GJS Plot F, Manchester

Non-material Amendment | 23.08.2024

Z1-SHP-A180-RP-XX-NMA02 | P02

Updated proposal - Z1-SHP-G100-PL-B2-B5D801 - P02

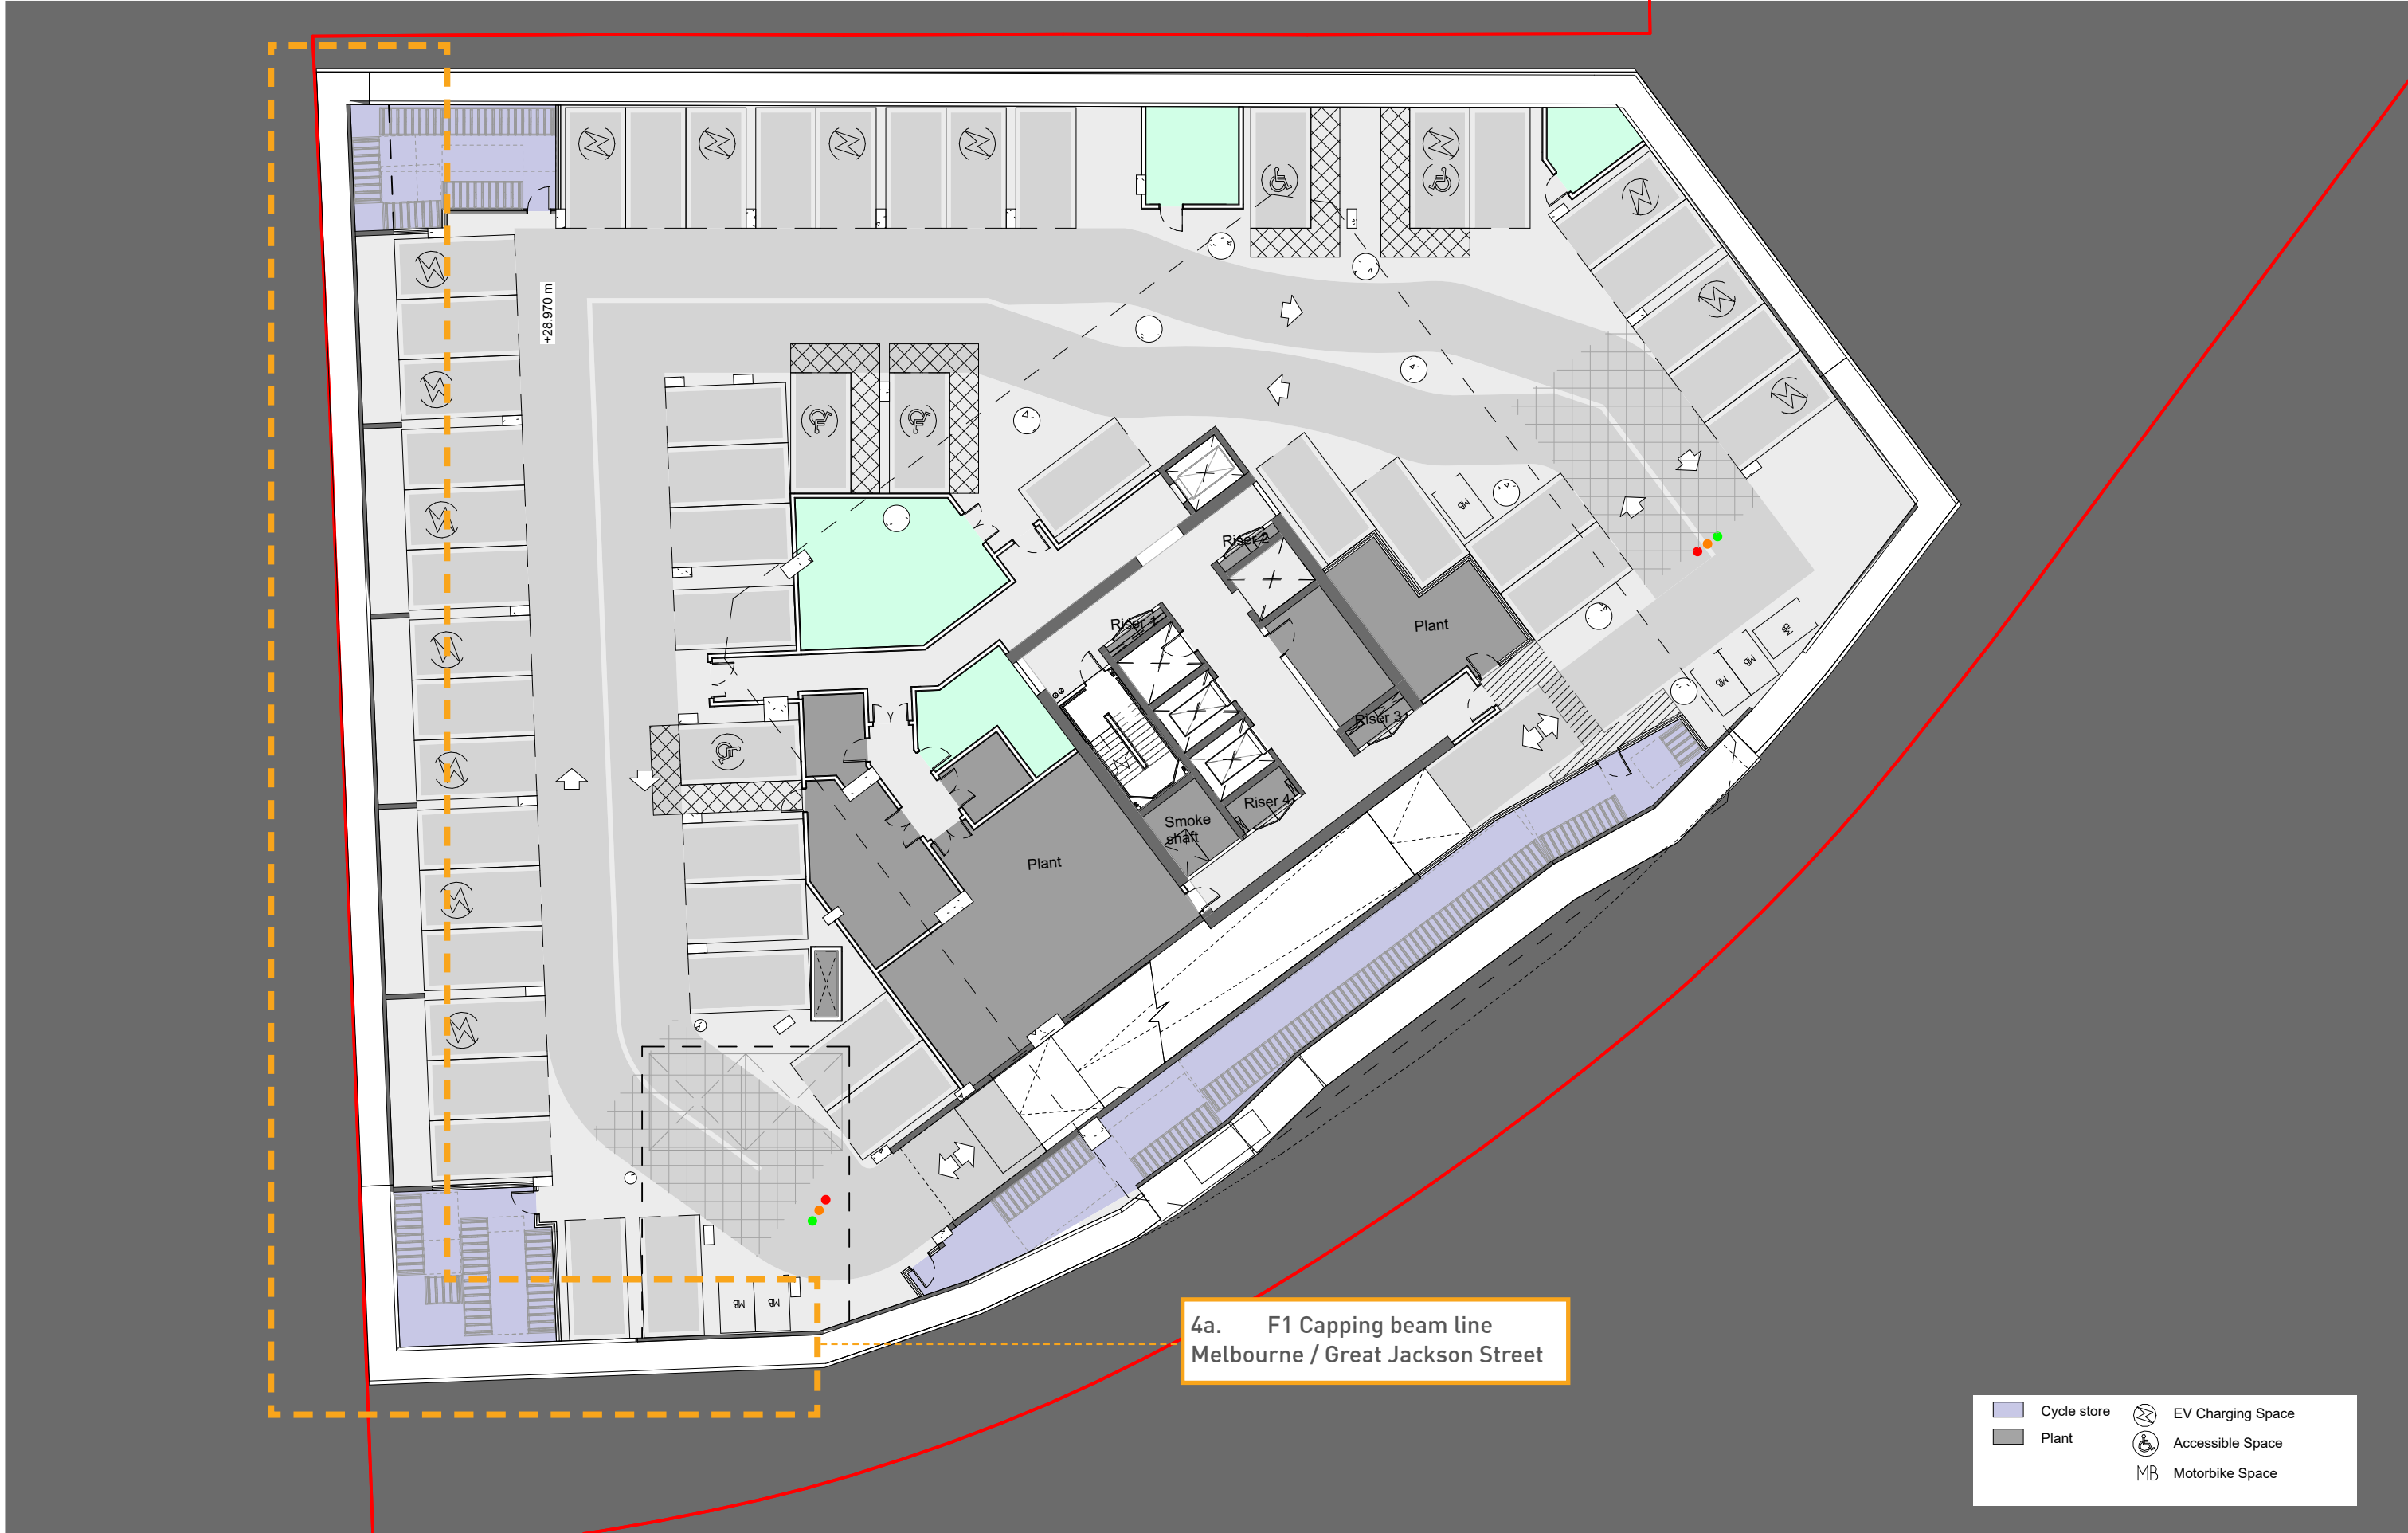
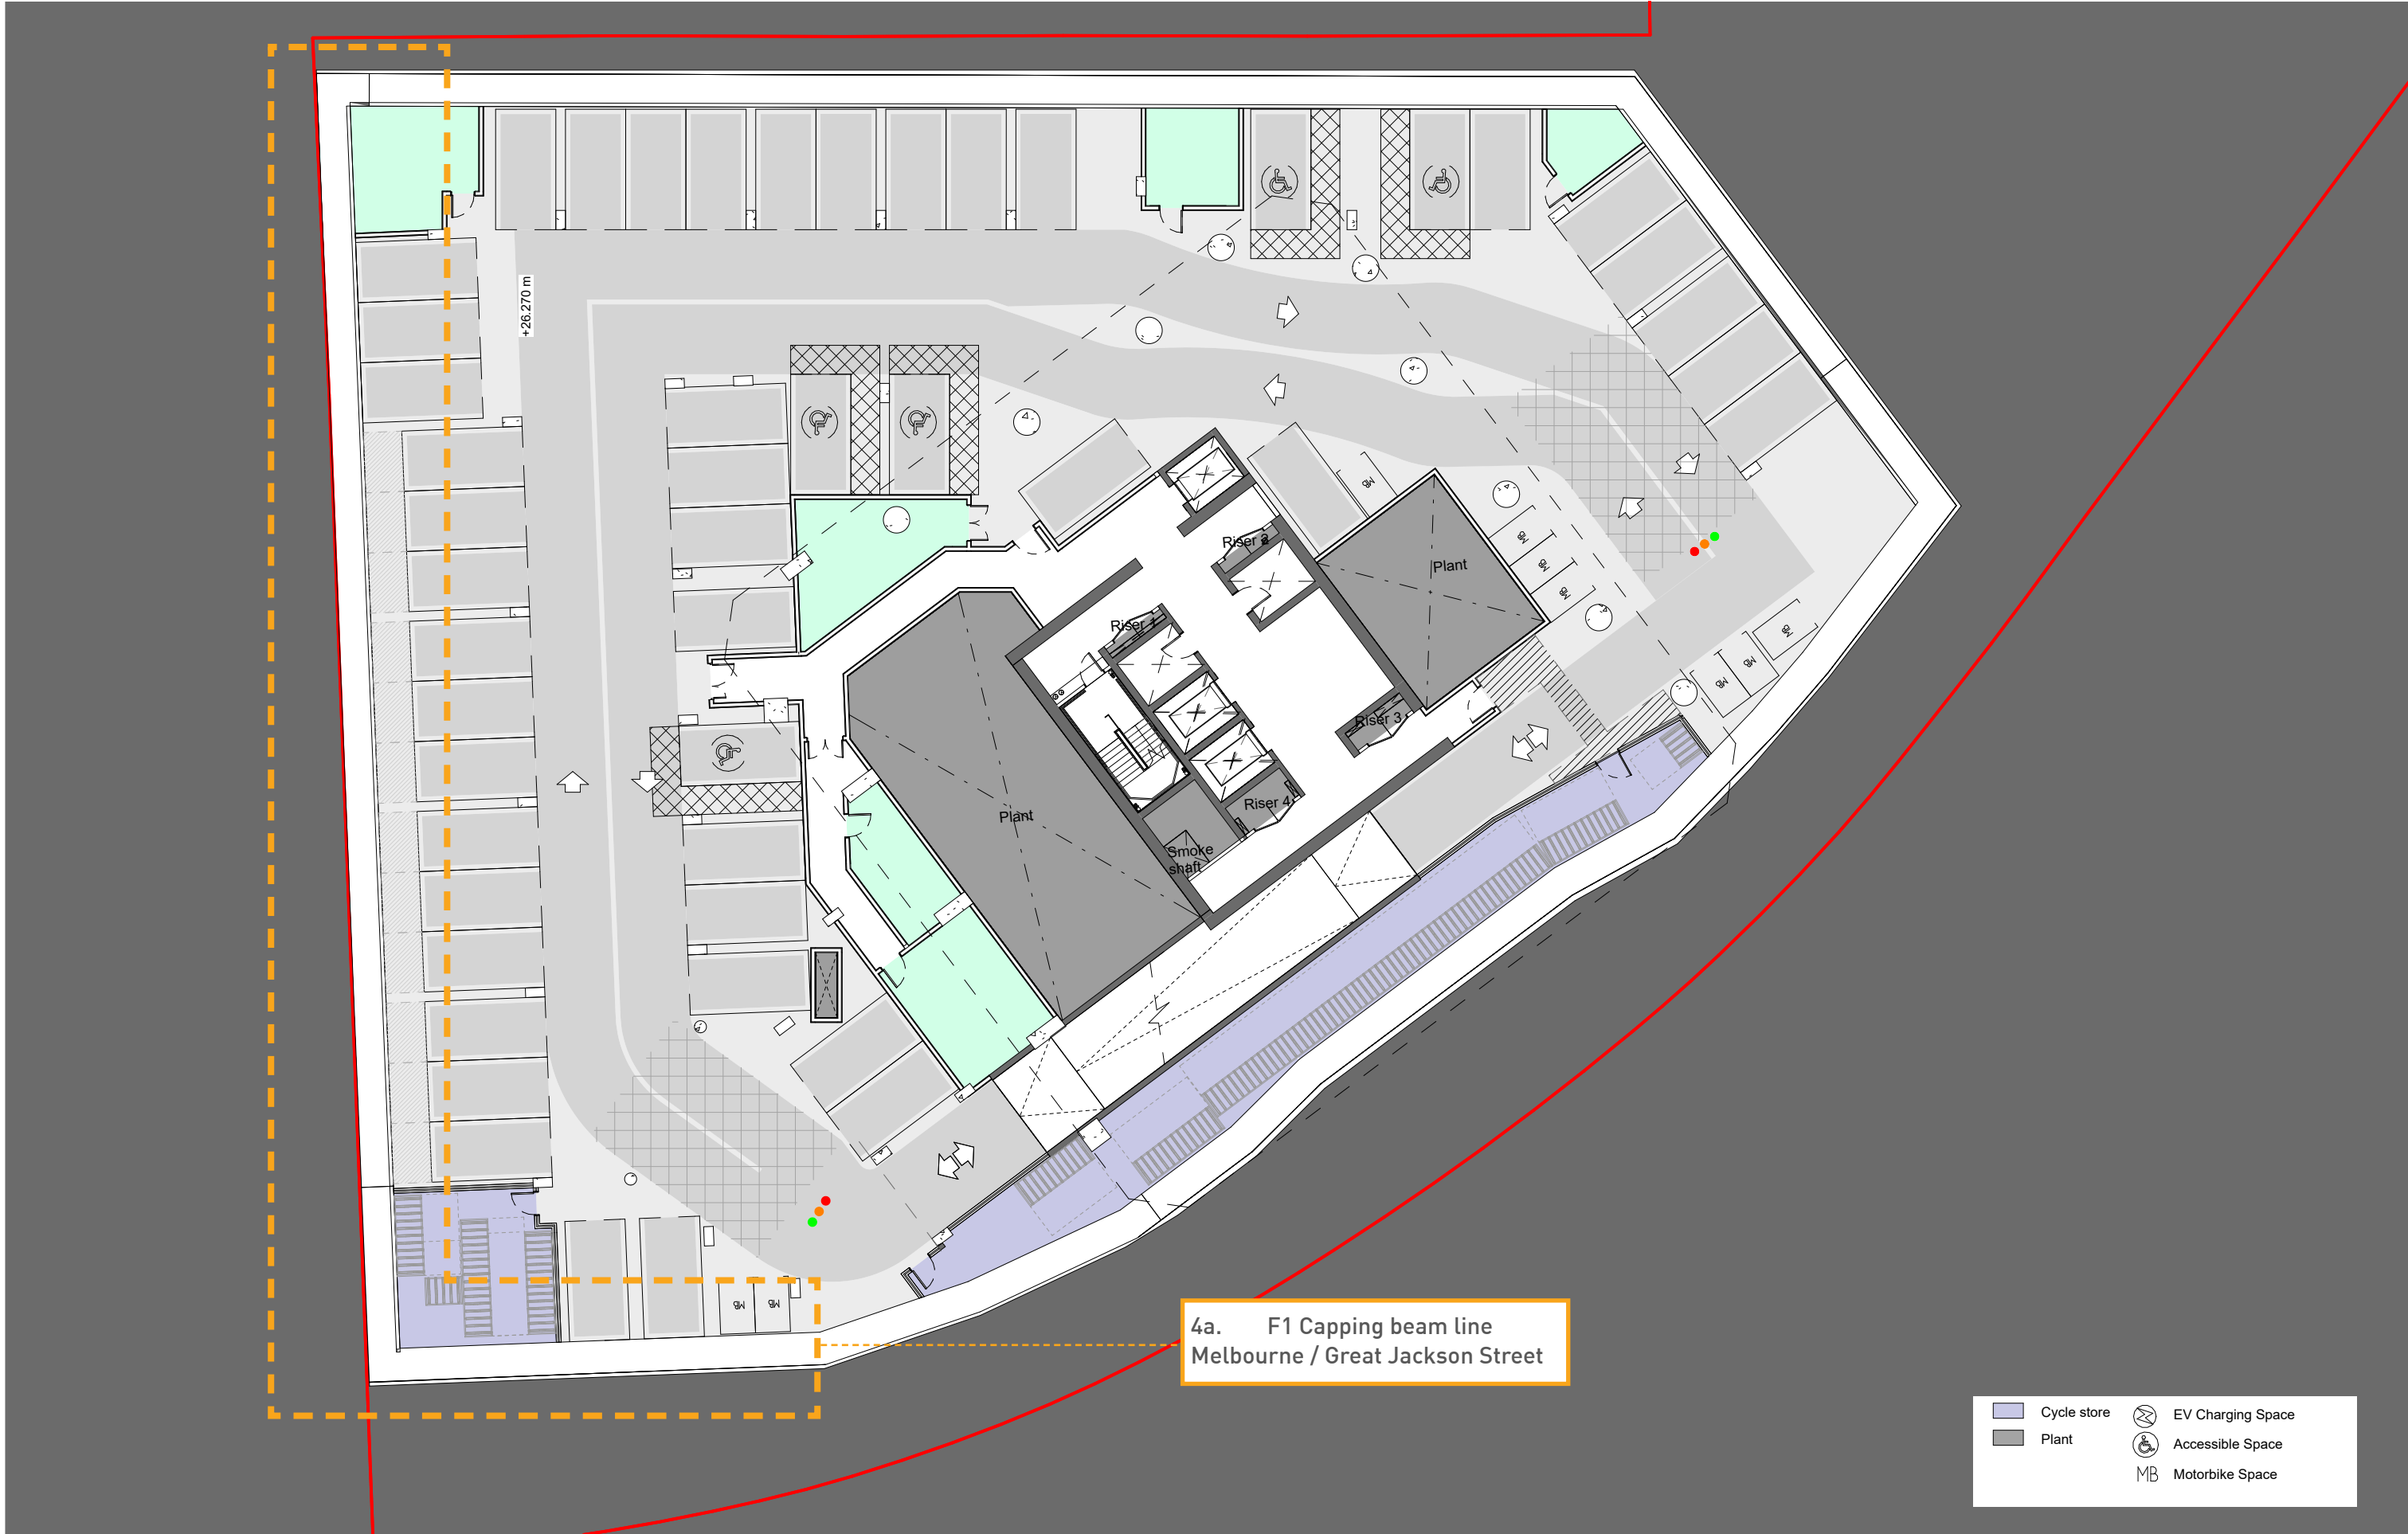
The alignment of the capping beam for the F1 basement running down Melbourne Street has also been amended to tie in with the Crown Street Phase 3 application.

The revised arrangement reflects the applicant’s updated land ownership and allows for construction efficiencies within the back to back basement design.

Updated Proposal - Z1-SHP-G100-PL-Grd-B5D801 - P05

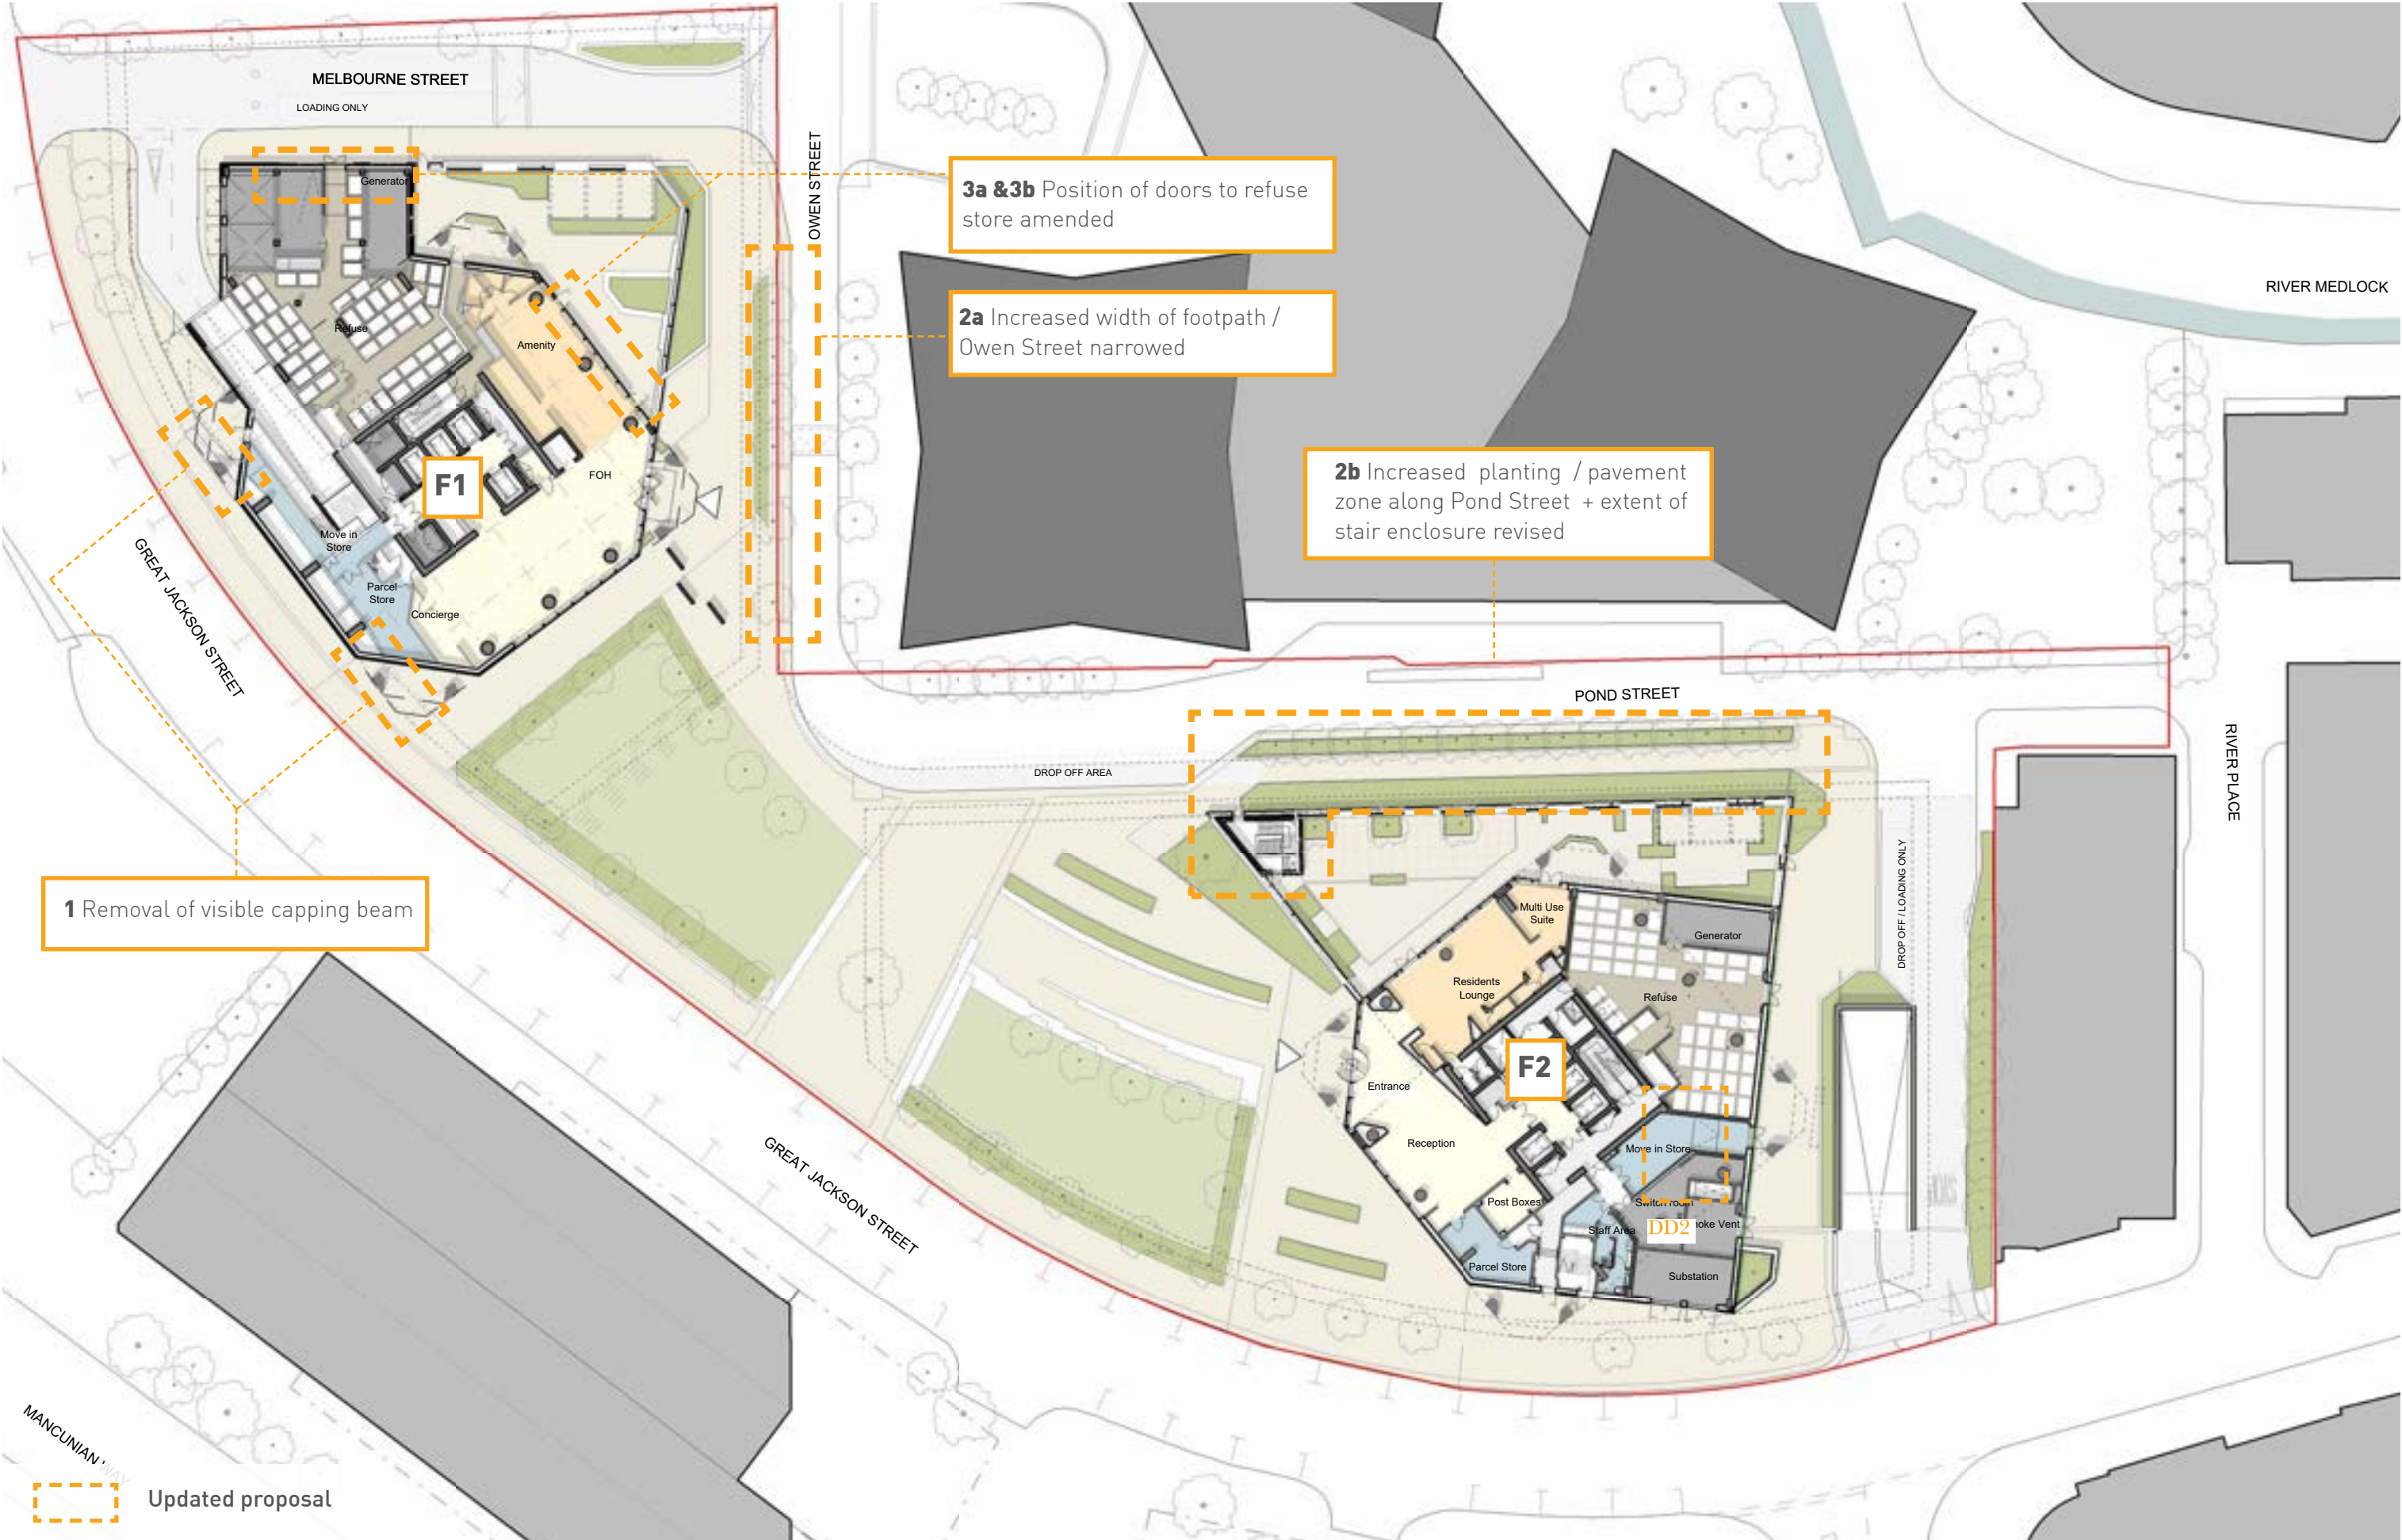
To create a more generous pavement area and help to define the one-way vehicular route to the southern end of Owen Street, it is proposed to narrow this section of the road, supported by the necessary highways tracking.
